Change No. 8  
 License No. DPR-23

CHANGE NO. 8 TO THE TECHNICAL SPECIFICATIONS

LICENSE NO. DPR-23

H. B. ROBINSON UNIT NO. 2  
MANAGEMENT ORGANIZATION CHART

Figure 6.1-1  
6.1-12

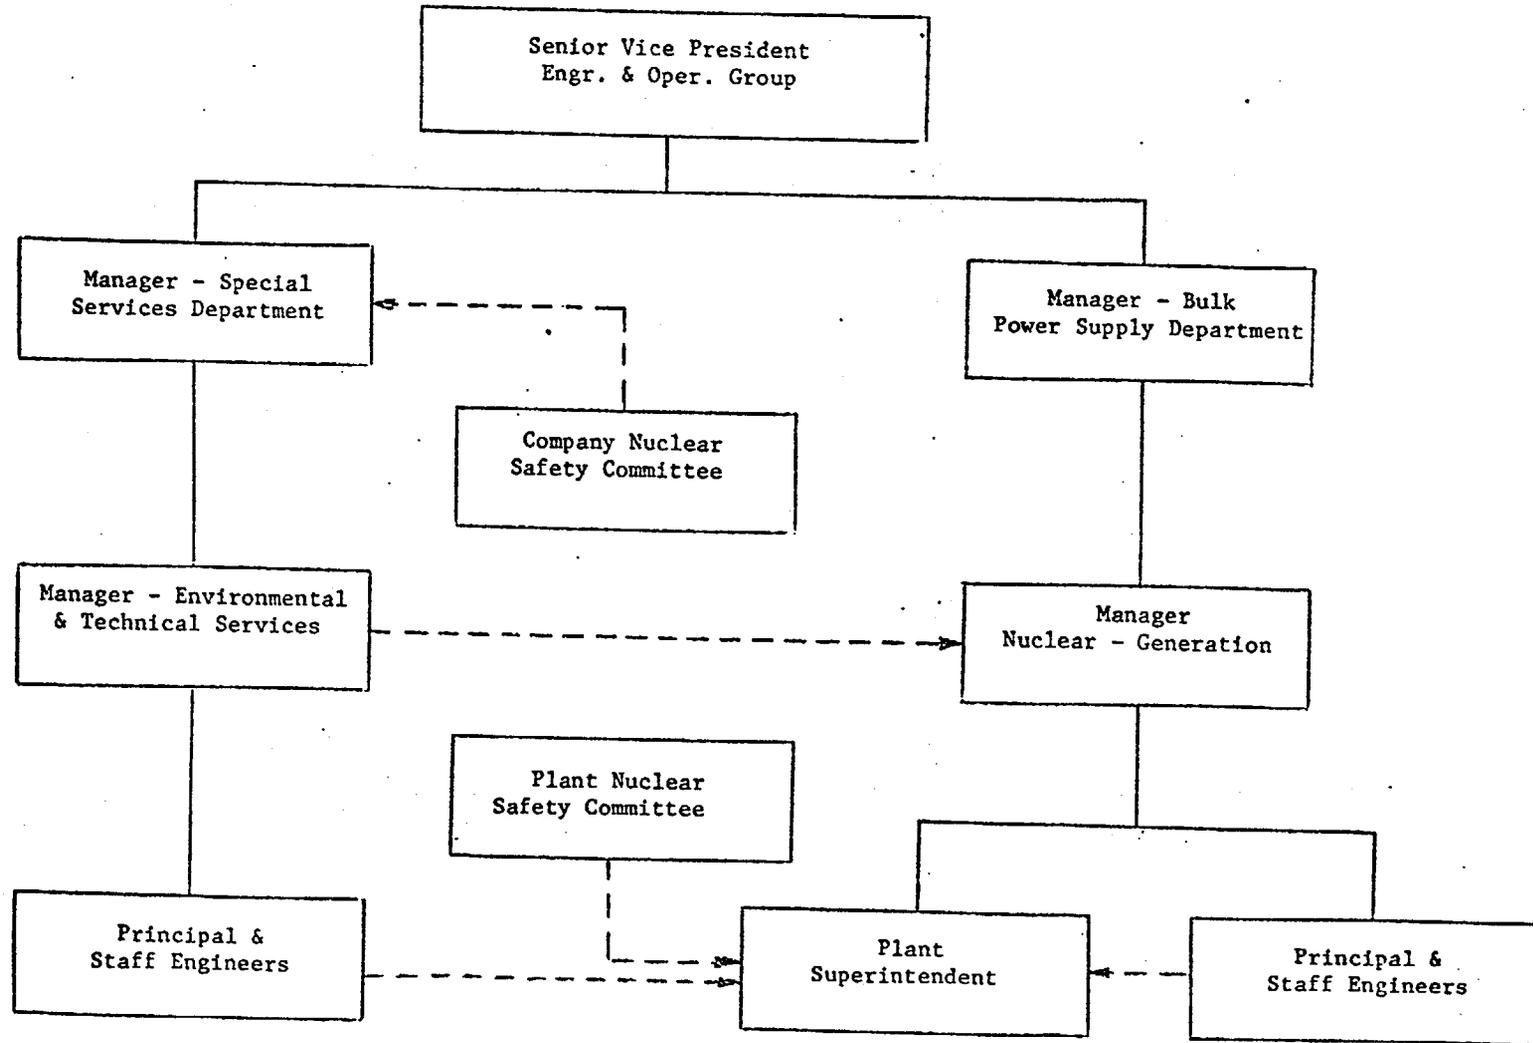
2. Replace Figure 6.1-1 (page 6.1-12) with the attached Figure 6.1-1.

(Revised with Change No. 8  
issued October 13, 1972 )
